BROWNS FERRY NUCLEAR PLANT (BFN) – UNITS 1, 2, AND 3 - TECHNICAL SPECIFICATIONS (TS) CHANGES TS-431 AND TS-418 – EXTENDED POWER UPRATE (EPU) – RESPONSE TO ROUND 19 REQUEST FOR ADDITIONAL INFORMATION (RAI) (TAC NOS. MD5262, MD5263, AND MD5264)

TENNESSEE VALLEY AUTHORITY
BROWNS FERRY NUCLEAR PLANT (BFN)
UNITS 1, 2, AND 3

RESPONSE TO ROUND 19 REQUEST FOR ADDITIONAL INFORMATION (RAI)

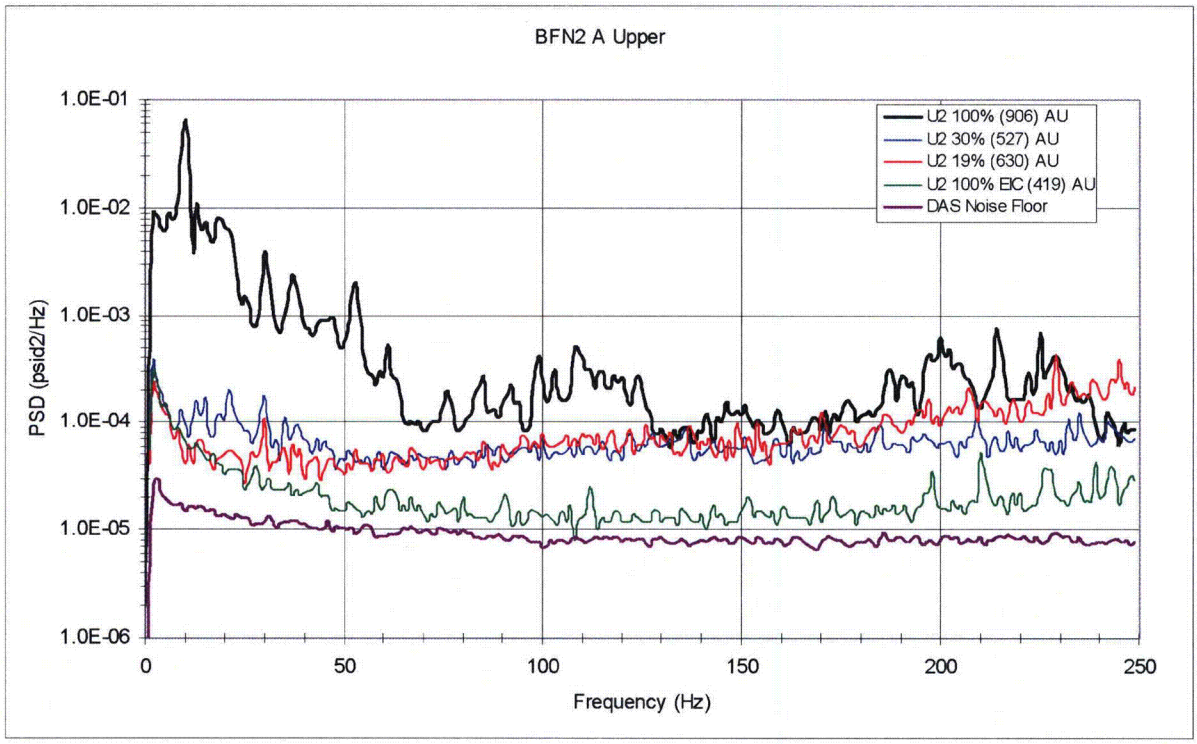
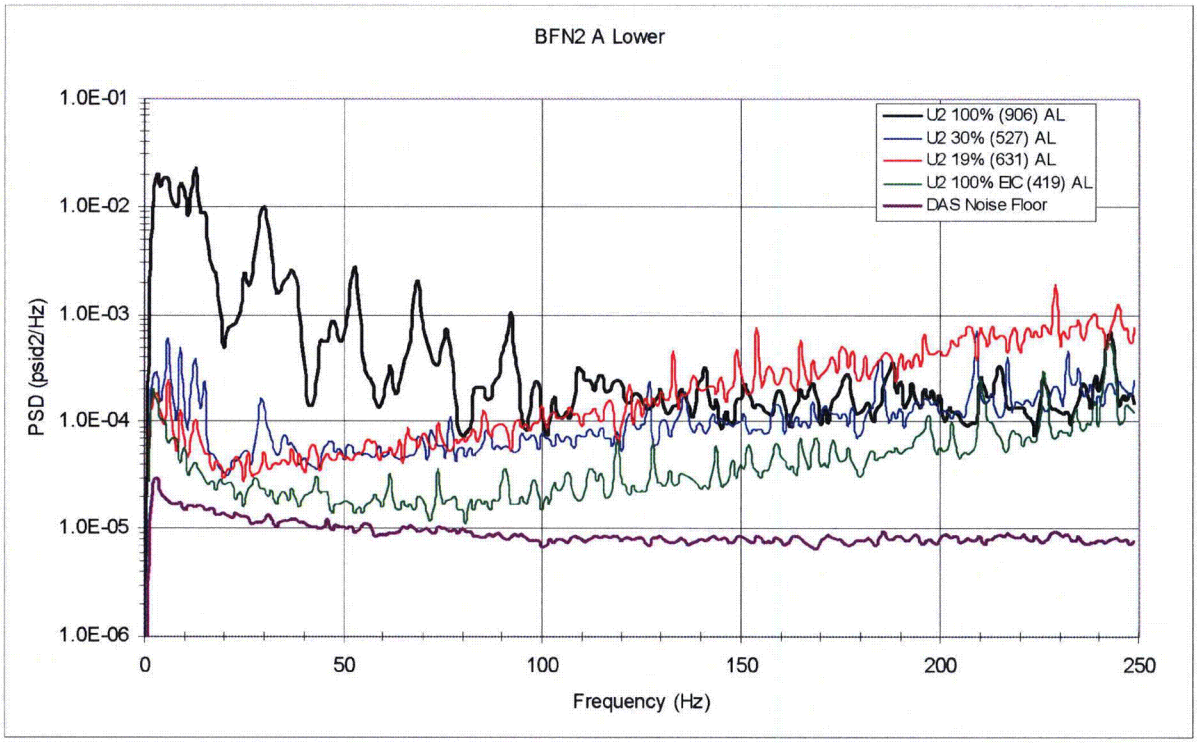
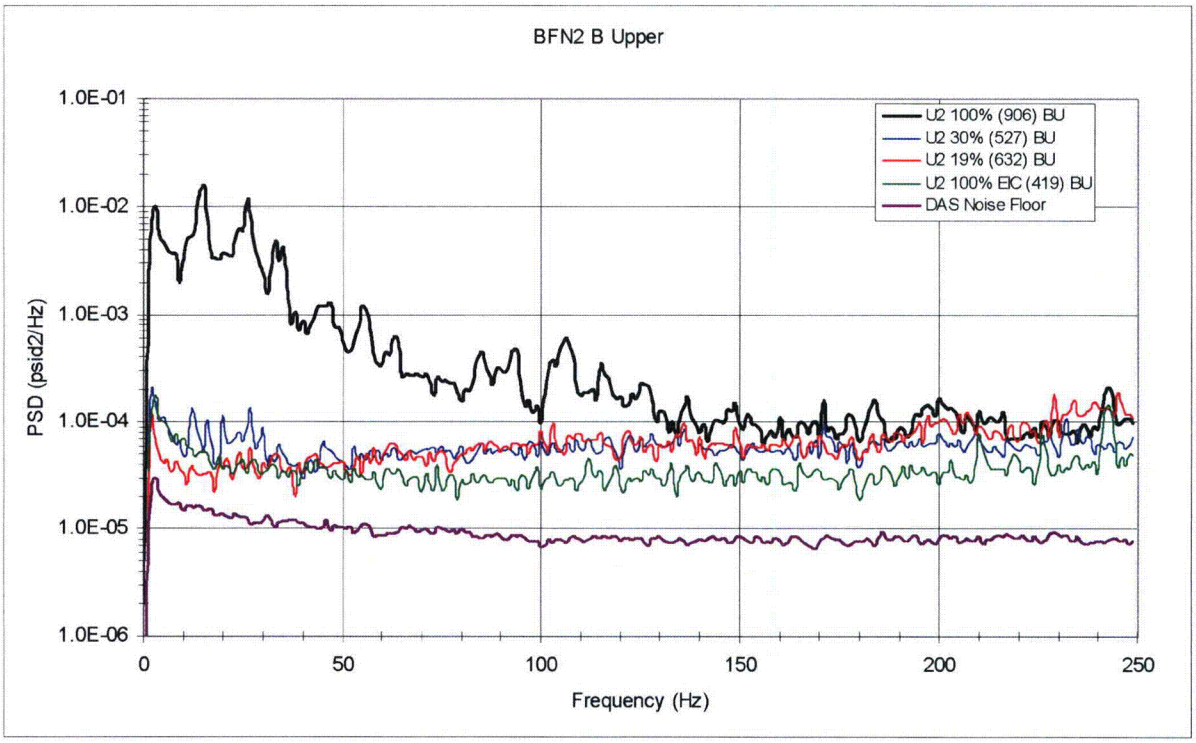
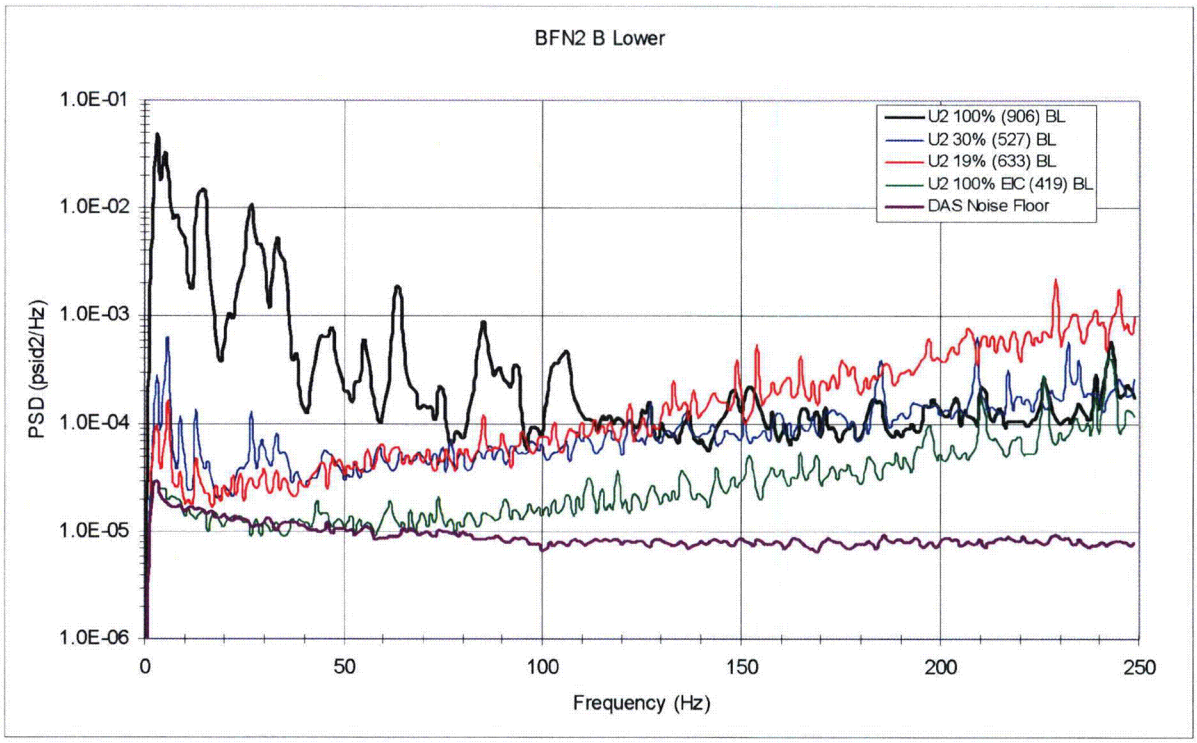
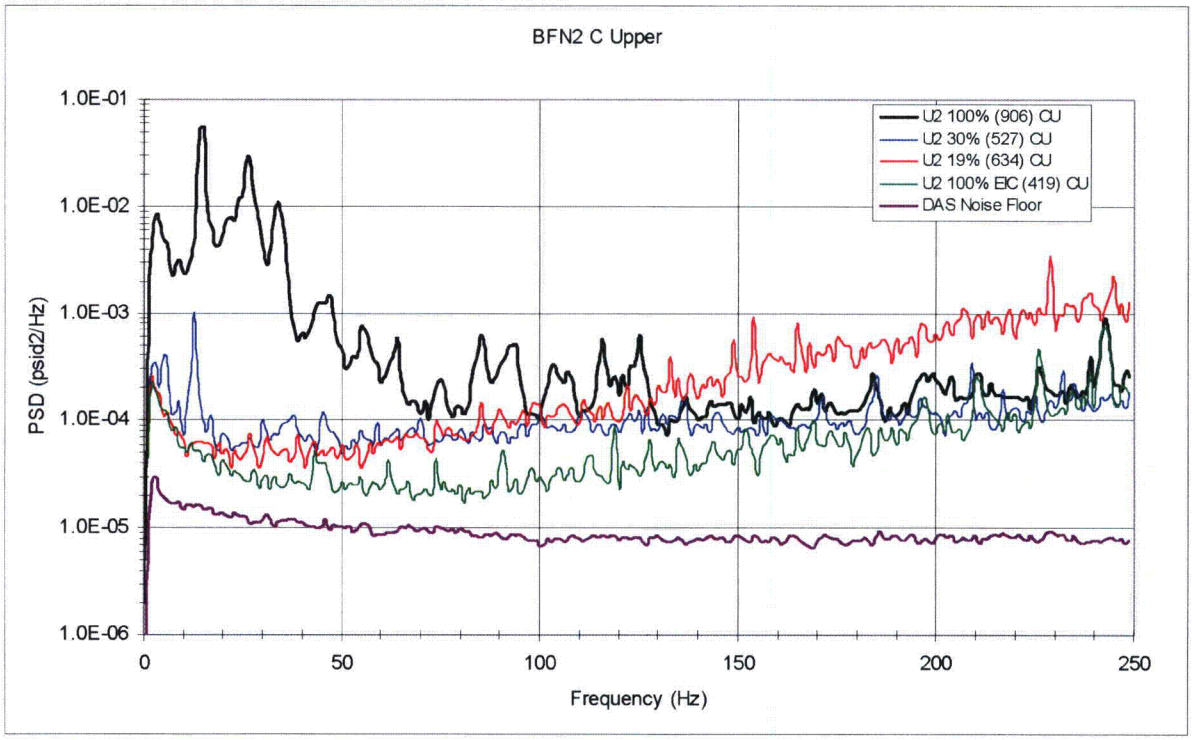
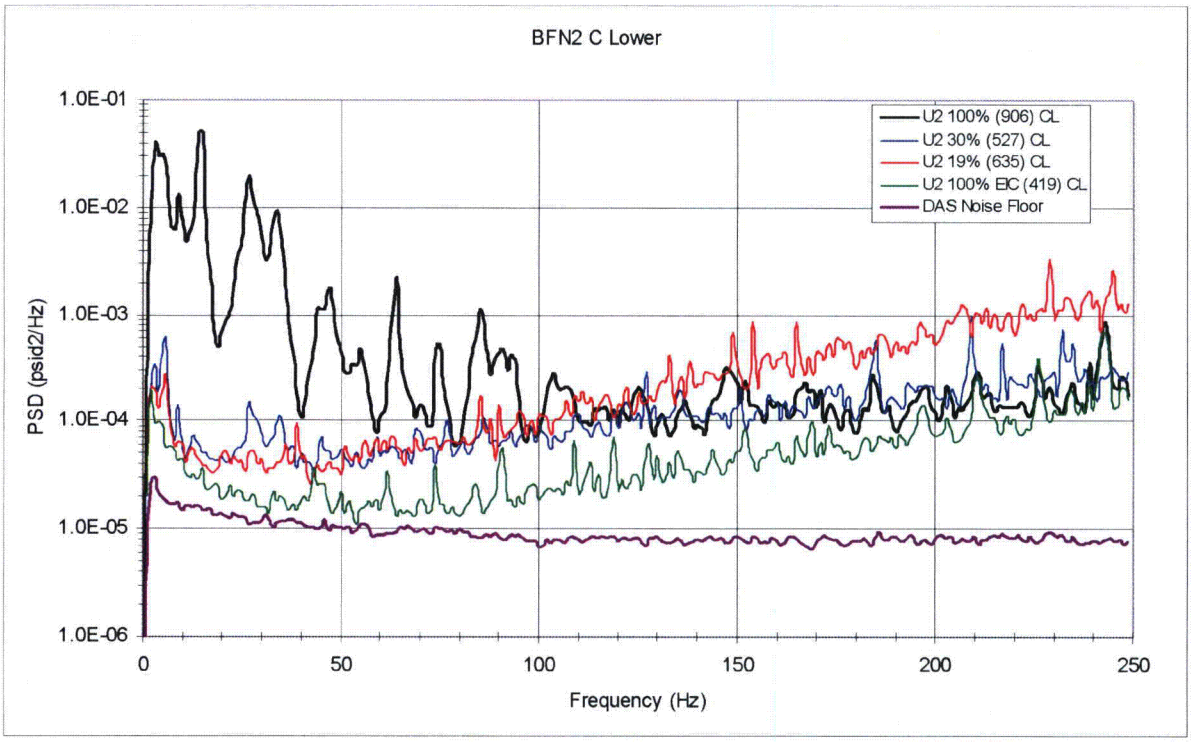
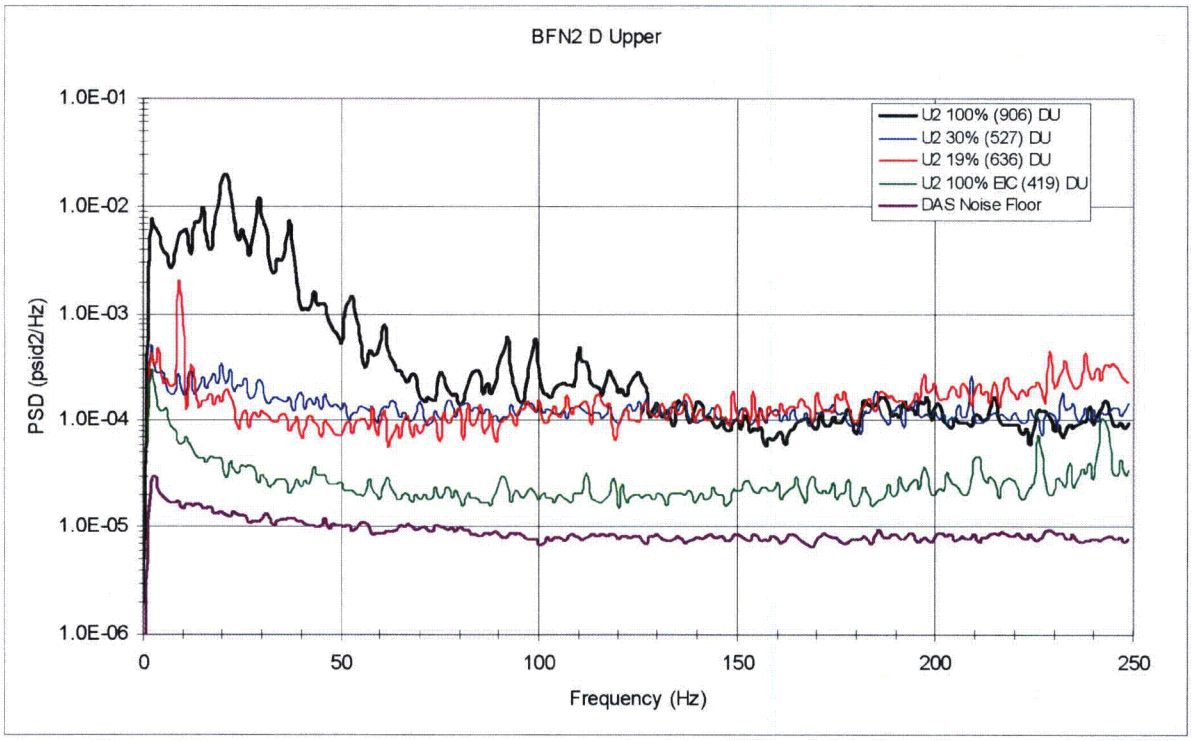
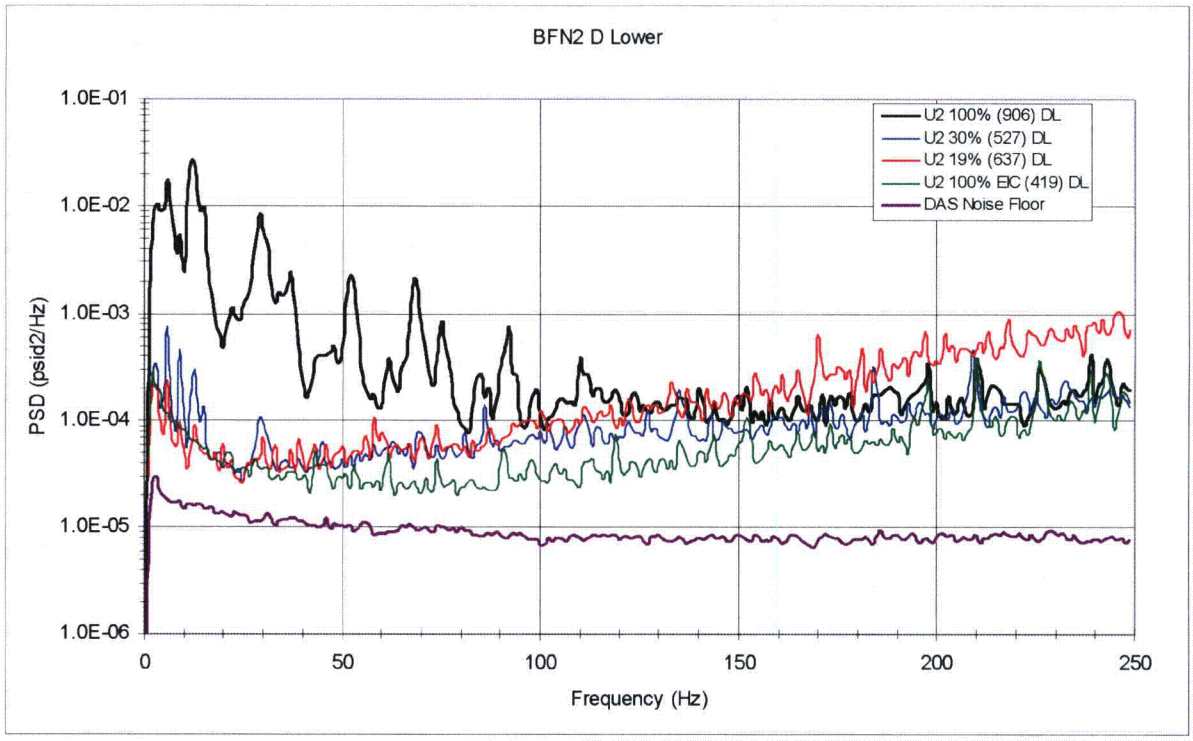
Provide analysis and plots for Unit 2 similar to those provided for Unit 1 in response to RAI EMCB.172. Provide an explanation why the 19 percent power data shown in Figures 3.2 through 3.5 in CDI Report No. 08-05P, *Acoustic and Low Frequency Hydrodynamic Loads at CLTP Power Level on Browns Ferry Nuclear Unit 2 Steam Dryer to 250 Hz*, are higher than the data at CLTP for frequencies above about 120 Hz. Provide justification for removing any signal from the Unit 2 CLTP source strengths without reliable background noise signals. TVA should include stress and stress ratio tables in CDI Report 08-16P, *Stress Assessments of Browns Ferry Nuclear Unit 2 Steam Dryer with Tie Bar and Hood Modifications*, using unfiltered MSL signals.

Figures EMCB.147-1a through 1d show PSD plots of available Unit 2 data including 19% power, 30% power, CLTP and an EIC signal taken at CLTP conditions. It can be seen from the EIC signal that Unit 2 data contains electrical noise that increases with frequency above 80 Hz. The most likely source of this noise is the VFD providing power to the 2A recirculation pump due to the close proximity of the strain gage signal penetrations to the pump power penetrations. The recirculation pumps are powered by VFDs which produce AC waveforms using multilevel pulse width modulation. Therefore, strong coupling of the signal may be expected to result in harmonic noise. By comparing the 19% power, 30% power and CLTP signals, it can also be seen that as power increases from 19% to 30%, the amplitude above 150 Hz decreases to that of the CLTP value. Analysis of Unit 1 data (see Figures EMCB.181-1a through 1d) shows that the amplitude of MSL strain gage data does not change significantly with steam flow and power level above 150 Hz. The most likely cause for the behavior of Unit 2 data is a decrease in the 150 - 250 Hz spectral content of noise contribution from the Unit 2 VFD as recirculation pump speed is increased from minimum speed (~16 Hz) at 19% power to ~ 25 Hz at 30% power.

Due to the unique noise characteristics of the Unit 2 data, the 30% power signal is more suitable for use as a LF signal at frequencies between 150 to 250 Hz. During a teleconference with the NRC on August 15, 2008, it was agreed that a composite LF signal would be developed by using the more limiting amplitude of the 19% power and 30% power signals at each frequency from 0 to 250 Hz. TVA is in the process of generating the composite LF signal to confirm that the Unit 2 stress analysis results remain acceptable using this signal. The results of this analysis will be provided by September 19, 2008.

Figure EMCB.187-1: Stiffener Shell Submodel and Full 3D Shell Model Stress Profile Comparison

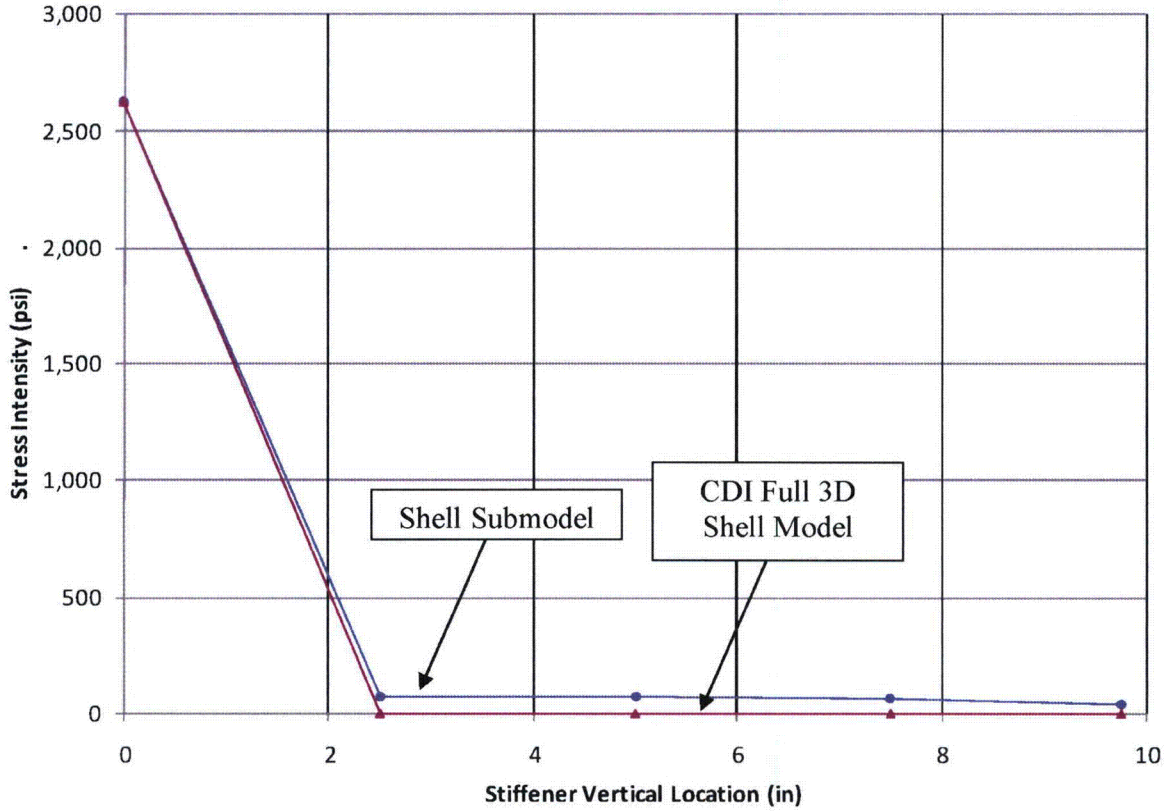
Figure 4.1 of the SIA calculations shows that 1,000 lb force is applied to the stiffener. Please explain why no loads are applied to Edges A, B and C? TVA is requested to provide the final applied load to the sub-model and a comparison of the resulting sub-model stress profile and the full model stress profile.

In the final iteration, the applied load is 267.2 lbs, evenly distributed over 1.75 inches of the stiffener height. Figure 4.1 of the SIA calculation shows the applied load 1,000 lb, which is the initial load used at the start of iteration. The actual load that corresponds to the full 3D shell model stress is 267.2 lbs.

The comparison of the stress profile in the shell submodel and the stress profile of the CDI full 3D shell model is shown in the Figure EMCB.187-1.

Figure EMCB.188-1: Drain Channel Model Applied Load

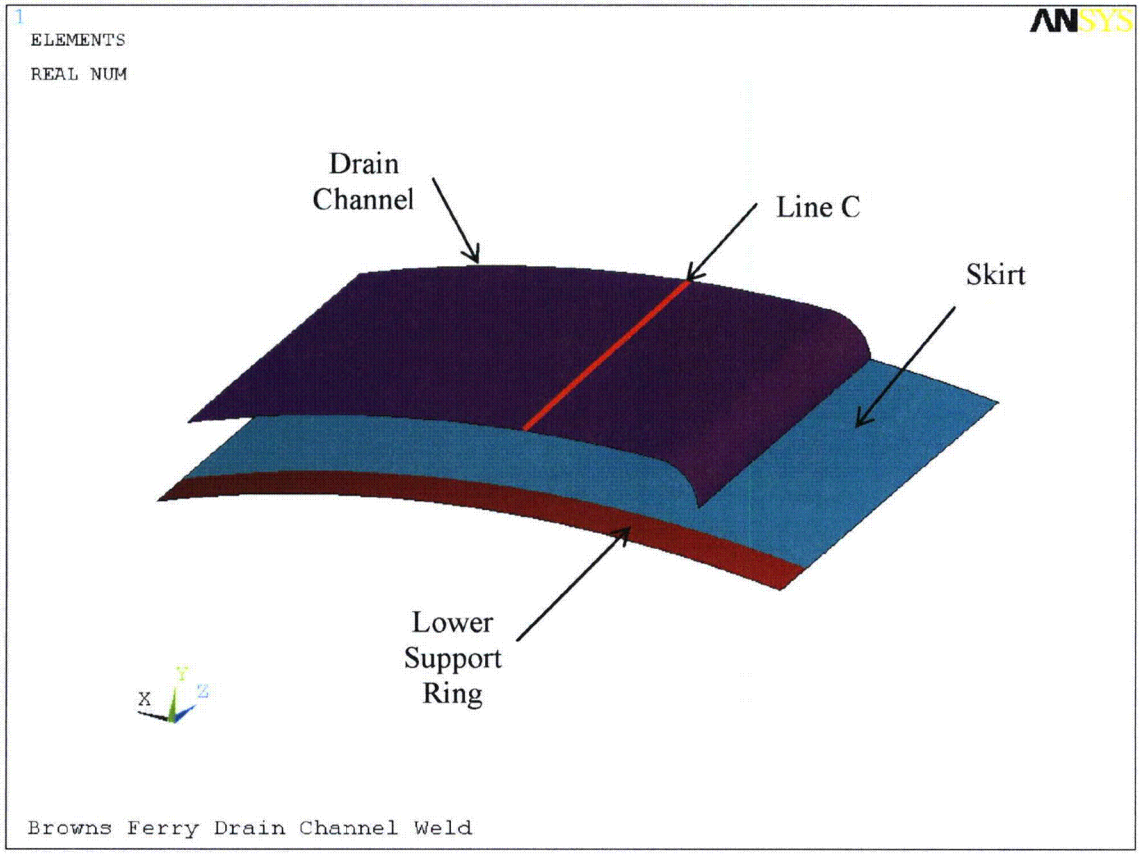
Explain the application of the prescribed displacements at the skirt/drain channel junction. Also explain the iterative analysis approach for the sub-model of the skirt/drain channel junction.

As described in the responses to RAIs EMCB.186 and EMCB.187, the mode of loading is not restricted to a particular type (i.e., force/moment versus displacement/rotation) as long as it produces a match in the weld connection stress. It was then switched to the application of displacements instead of forces at the location as shown along Line C in Figure EMCB.188-1.

Along Line C: Imposed outward radial displacements along the line at 1 inch regular intervals.

Figure EMCB.189-1: Drain Channel Imposed Displacements

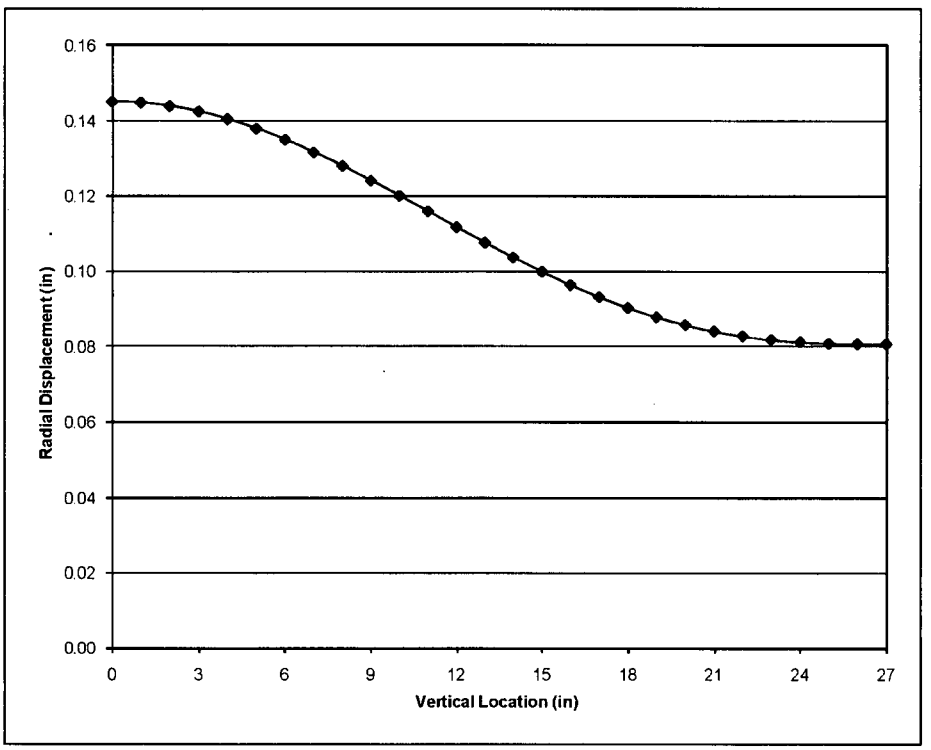
Provide the final magnitude of imposed displacement along with the location and a comparison of the resulting sub-model stress profile and the full model stress profile.

A plot of the final imposed drain channel/skirt displacements is provided in Figure EMCB.189-1.

The imposed displacements are in the outward radial direction along the vertical Line C (see Figure EMCB.188-1). The maximum magnitude of displacement is 0.145 inch at the bottom, reducing to 0.08 inch at the top of the modeled drain channel. Figure EMCB.189-2 shows the comparison of the stress profile.
